## SUTHERLAND SHIRE COUNCIL ASSESSMENT REPORT

<b>Panel Reference</b>	PPSSSH-3
<b>DA Number</b>	19/0472
<b>LGA</b>	Sutherland Shire
<b>Proposed Development</b>	Demolition and excavation of existing Engadine Tavern carpark and construction of a residential flat building containing 64 units above a shared basement carpark comprising 80 residential spaces and 70 spaces to be used for the adjacent Engadine Tavern
<b>Street Address</b>	5 Preston Avenue, Engadine
<b>Applicant</b>	George Ajaka White and Partners
<b>Owner</b>	Engadine Tavern Development Sub Trust Sutherland Shire Council (partial land owner until land swap approved as part of DA19/0638 is enacted which will facilitate development subject of this application)
<b>Date of DA lodgement</b>	27 June 2019
<b>Number of Submissions</b>	Seven submissions from five properties during 1 <sup>st</sup> notification period Five submissions from five properties during 2 <sup>nd</sup> notification period

<b>Report prepared by</b>	Lauren Franks - Environmental Assessment Officer Sutherland Shire Council
<b>Report date</b>	4 June 2020

Figure 5: Potential redevelopment option for 7 Preston Avenue, Engadine

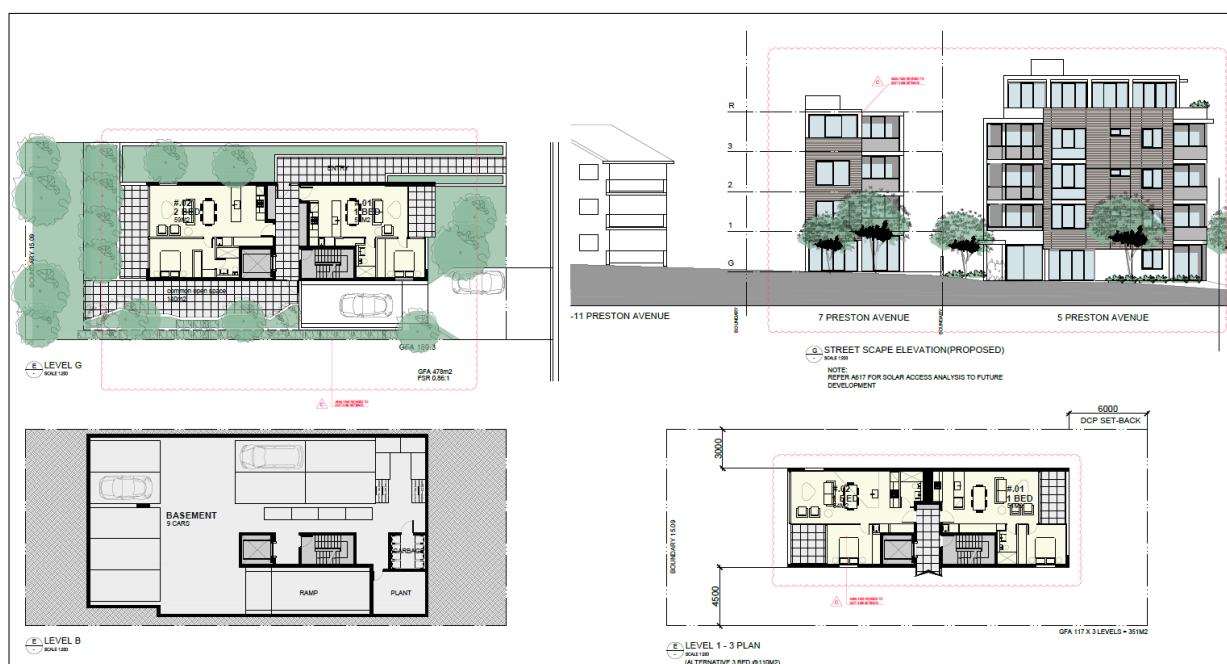
The applicant has provided a scheme demonstrating how No. 7 Preston Avenue could be redeveloped in isolation, considering building separation controls along with other key requirements of the ADG and SSDCP 2015 (refer plan extract below for drawing A701 – C).

Whilst this plan is schematic, this drawing has been revised as the proposal has evolved. The scheme has a FSR of approximately 0.83:1 and height of 4 storeys, below the maximum permitted FSR of 2:1 and 20m height limit (which typically allows for a 5-6 storey building). While this scheme does not exhaust the allowances in FSR and height controls permitted by the SSLEP 2015, the applicant has noted that an alternate scheme which introduces commercial premises would have the potential to increase the FSR achieved on the site.

Figure 6: Separation between the buildings on site at level 5.

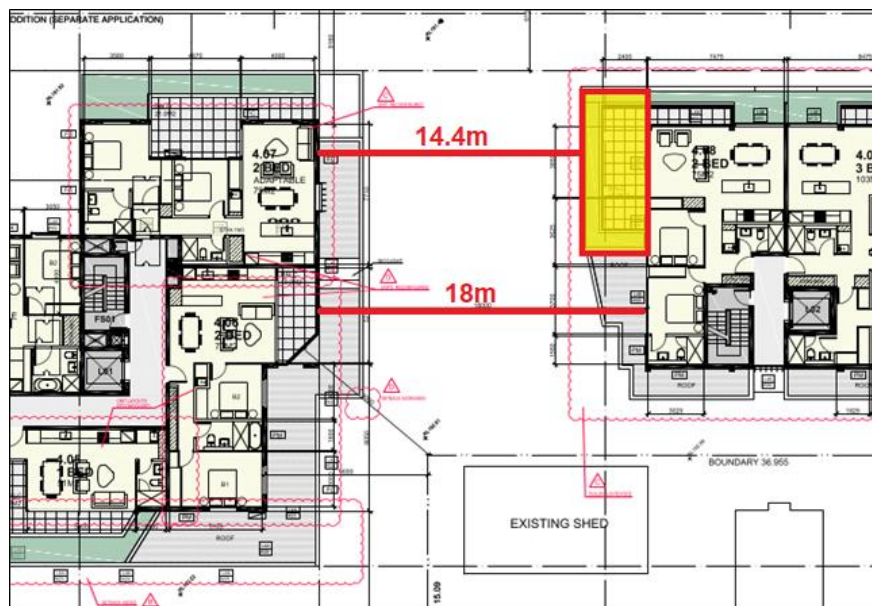
The ADG stipulates that a 12m building separation is achieved for the first four storeys where this distance is measured between habitable rooms / balconies. This distance is to widen to 18m for the 5<sup>th</sup> storey. A 12m building separation between Building 'A' and Building 'B' is achieved for the first 4 storeys, however a 14.4m separation is proposed at the 5<sup>th</sup> storey, representing a non-compliance of 3.6m (20%). Non-compliance occurs due to an encroachment from unit 4.08's balcony which partially extends within this space. When excluding this balcony, an 18m setback is achieved between the buildings. The plan extract below identifies this non-compliant portion of Building 'B':

The intent of this control is to minimise building bulk at upper levels and achieve privacy between dwellings. This is achieved as the unit directly opposite within Building 'A' has a defensive façade, limiting a direct line of sight from the living space of unit 4.08 into this unit. The offending balcony also has a 1m wide planter box around its perimeter to provide an additional layer of privacy. Further, the balcony is unroofed so bulk associated with this element is limited to 1m from the storey below so minimal bulk will result from non-compliance.

Figure 7: Building Separation Distances to No. 7 Preston Avenue

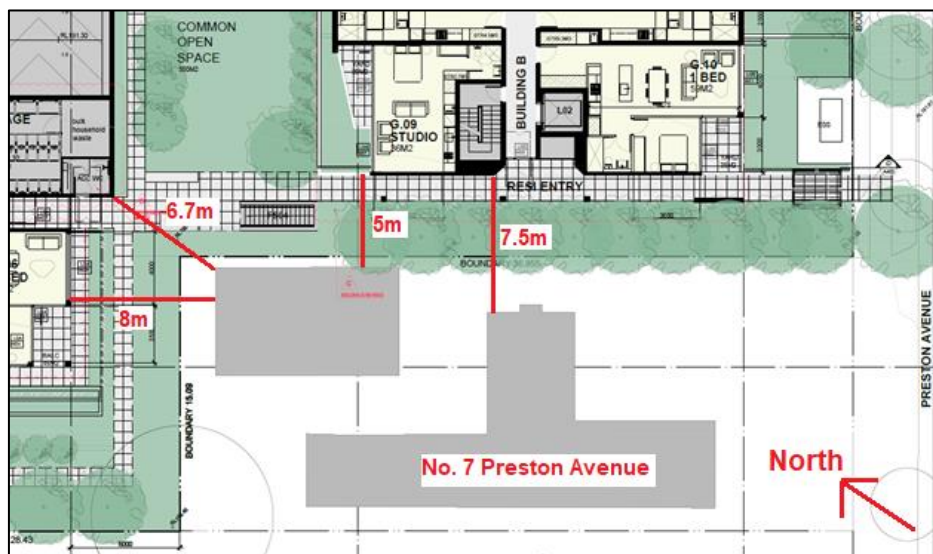
With regards to No. 7 Preston Avenue, this site is occupied by a single storey building that contains 2 dwellings which are used as 'service apartments'. No formal approval has been issued by Council to authorise this operation. Its historical use has been as a single storey dwelling house. That aside, in assessing the proposal's relationship with this property, a 4m setback is provided at the ground level when measured from Building 'B' and is defensive in its design, compliant with the ADG. In considering the separation between buildings, the garage (converted into a serviced apartment) is situated 1m from the shared boundary and does not contain any windows. This provides a 5m separation, representing a non-compliance of 1m as seen below:

The 5m setback distance is acceptable given the garage has a defensive north-eastern façade orientated towards Building 'B', is a property used for short stay periods and is likely to be redeveloped in the future. Whilst a 4m setback is provided at the ground floor, this reduces to 3m for levels 1-3 and increases to 4.72m at level 5. This elevation is defensive, introducing windows with a 1.8m sill height to achieve privacy and slatting over lobby windows that are centrally position down the elevation.

Figure 9: Setback and separation distances between Building 'A' and No. 9-11 Preston Avenue.

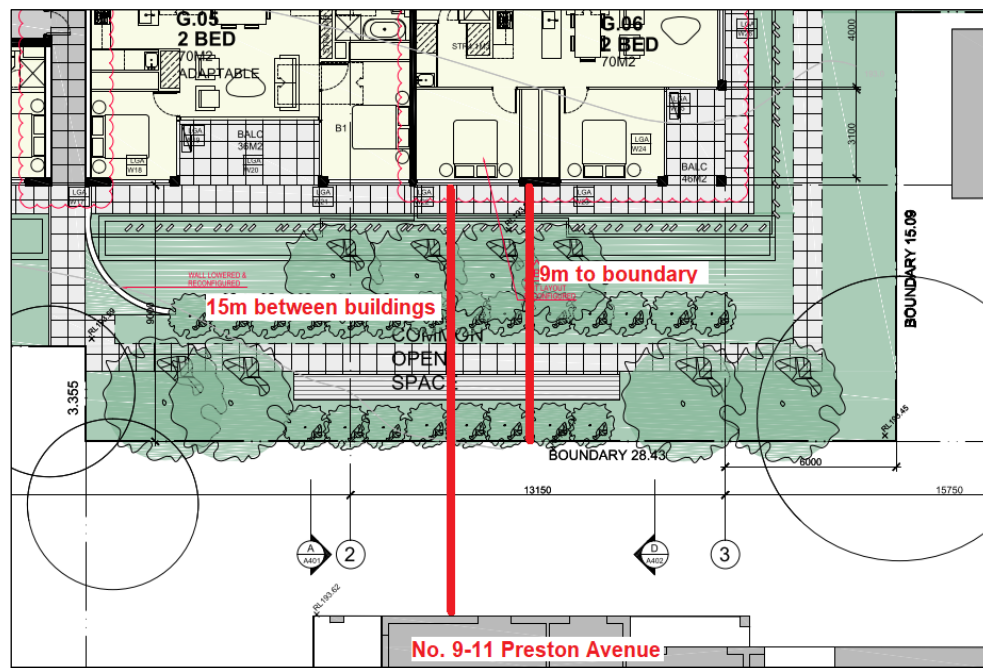
No. 9-11 Preston Avenue partially adjoins the south-western boundary and is occupied by a 3 storey residential flat development. The proposal applies a 9m setback for the first four storeys, compliant with the ADG. With regards to building separation, 12m has been achieved. The portion of this adjoining property aligning with Building 'A' on the site is shown below:

This setback distance has applied the additional 3m required where a transition between zones occurs. The floor plate visible in the figure above is replicated for an additional 3 storeys above the ground floor plan extract below. The applicant has also re-worked the design to increase the setbacks to the 5<sup>th</sup> and 6<sup>th</sup> storey where it aligns with No. 9-11 Preston Avenue to provide a 12m setback to the shared boundary (noting a slight protrusion of 1m occurring for a small portion of a balcony at the 5<sup>th</sup> storey). It is also noted that the basement is setback 6.4m from the boundary shared with No. 9-11 Preston Avenue and considerable amendments have occurred to the Landscape Plan to introduce further planting within this setback to soften the visual bulk of the development.

Figure 11: Most affected unit in relation to overshadowing. Shadow cast ceases at 1pm for No. 6/9-11 Preston Avenue

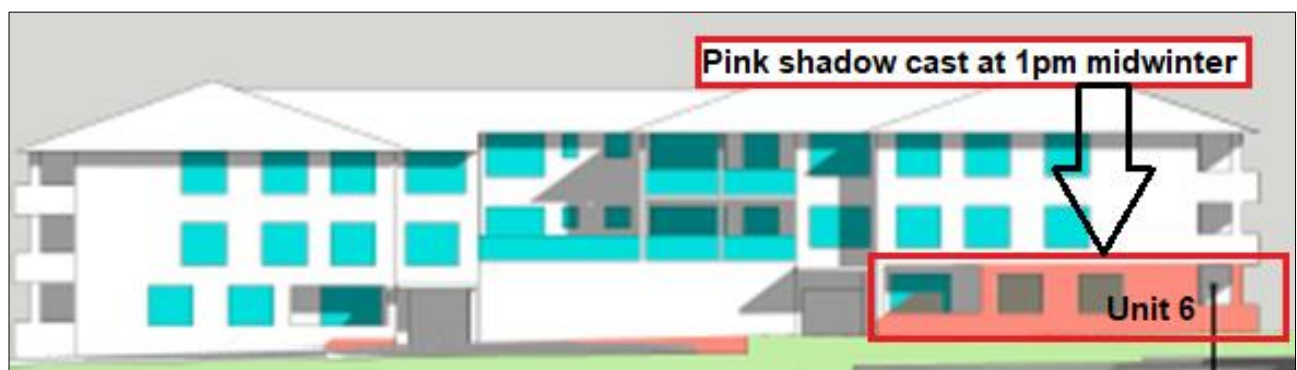
It should be noted that along the north-eastern elevation, No. 9-11 Preston Avenue is in full shadow at 3pm. This is due to existing shadow cast from its own building. The last time of the day where shadow casts onto No. 9-11 President Avenue from the proposed development is at 1pm, which impacts unit 6 only as shown below:

Figure 12: Suns eye view diagrams showing the level of solar access gained to No. 6/9-11 Preston Avenue

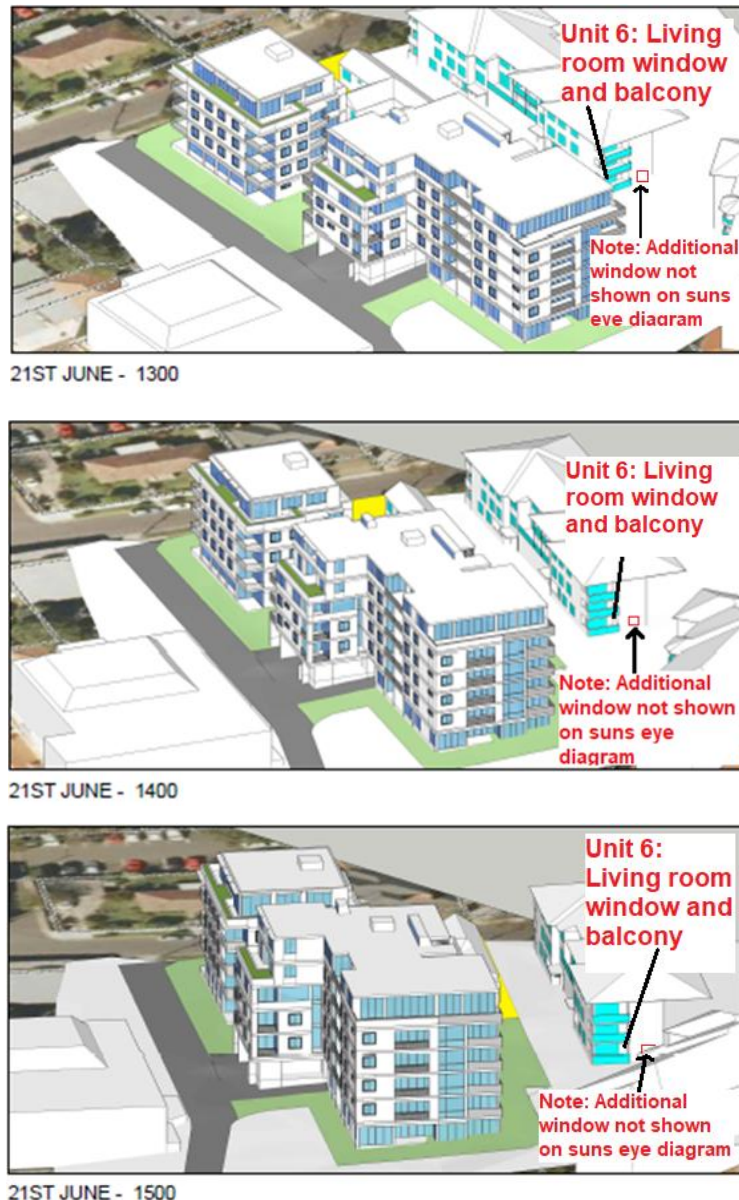
No. 9-11 Preston Avenue adjoins Council owned land (identified as No. 1058-1062 Old Princes Highway) that is undeveloped and vegetated. At 3pm, it is evident from the suns eye diagram below that unit 6 will have the capacity to receive sunlight (albeit, filtered due to scattered vegetation across the adjoining Council land) at 3pm onwards:

It is accepted that currently, units within No. 9-11 Preston Avenue experience unobstructed solar access between 9am and 3pm midwinter due to the site's use as a carpark. The degree of change will be significant however, whilst amendments to the proposal's distribution of bulk across the site have been made to minimise overshadowing to adjoining properties, it is inevitable that some overshadowing to this adjoining property will occur due to its position being south-west of the site.

*Figure 13: South-western elevation of Building 'A' identifying portion of proposed building that will align directly with the residential flat building on No. 9-11 Preston Avenue.*

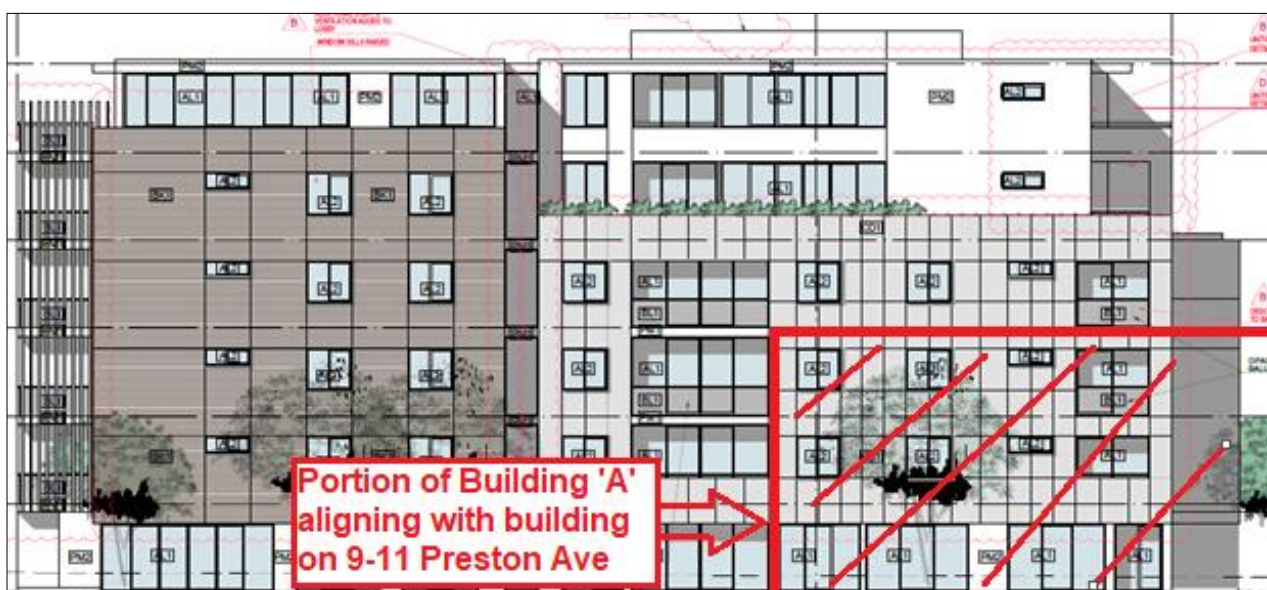
Various submissions raised visual privacy as an issue with the proposal. As discussed earlier in the report, the proposal has undergone modifications to achieve compliance with setbacks and building separation requirements which has aided impacts associated with visual privacy. Further to this, internal unit layouts have been revised and the treatment of building elevations adjacent to residential properties has evolved through the assessment process to include 1.8m high sill windows where it is a secondary bedroom window / bathroom / laundry, opaque glass balustrades and replacement of floor to ceiling bedroom windows with 1.2m high sill windows. To relocate the balconies of unit's 1.06, 2.06 and 3.06 so that they don't align with the residential flat building on No. 9-11 Preston Avenue is difficult to achieve given this southern corner of Building 'A' aligns with two residential properties (the second being No. 7 Preston Avenue) as per the following plan extracts:

It is unavoidable to have the development incorporate a completely defensive façade where the building aligns with a residential property. However, on balance the building has an acceptable relationship with adjoining residential properties and is not excessive in their provision of glazing and balcony sizing to warrant further design changes to be made. The proposal's compliance with setback and building separation controls with No. 7 Preston Avenue and No. 9-11 Preston Avenue allows for ample deep soil landscaping within setbacks to relieve any overlooking between properties.

Figure 15: Typical floor plate for Level 1-3 where 9 units are proposed per floor

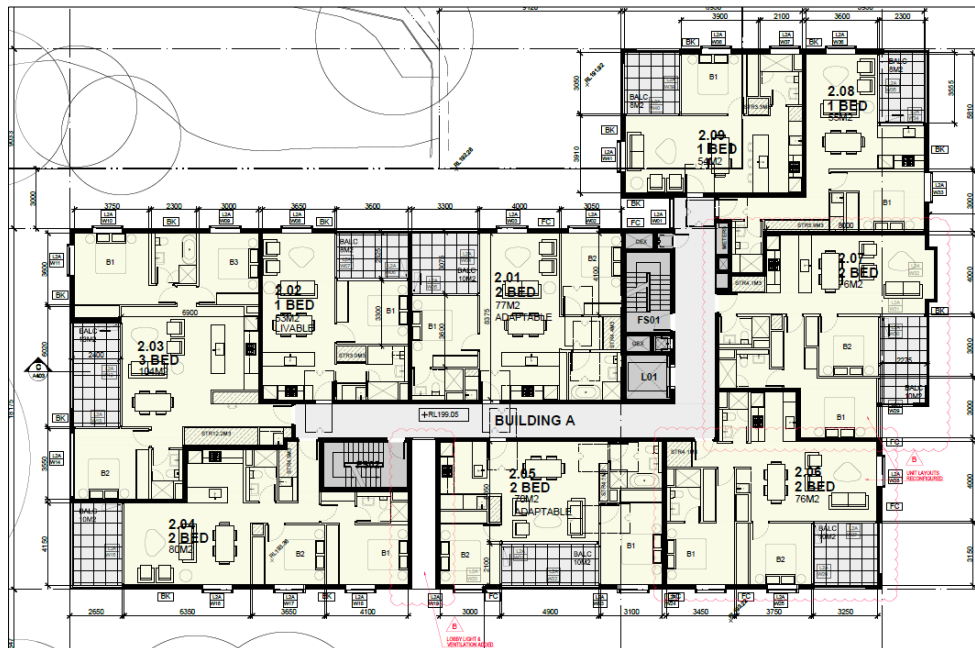
The ADG stipulates that a maximum eight units should feature off a circulation core on a single level. Three levels within Building 'A' have 9 units per floor where only one lift is provided. Building 'A' contains a total of 48 units and is 6 storeys. The ADG states that this applies to buildings of 10 storeys or more.

As the levels in which the single lift services nine units are situated close to the ground, the time taken for the lift to move between floors and the ground or basement levels will be reduced which will improve the waiting time. In some instances, occupants may choose to use the stairs should they need only move between a few floors. Further to this, the floors which don't comply include small sized units (each containing 3 x 1 bedroom units), likely to be occupied by one resident as shown below:

A second lift would also see strata premiums raised for future occupants. Future owners will be aware of the size, design and amenity of the development and therefore will know upfront what they will be buying into. For these reasons, non-compliance is supported.
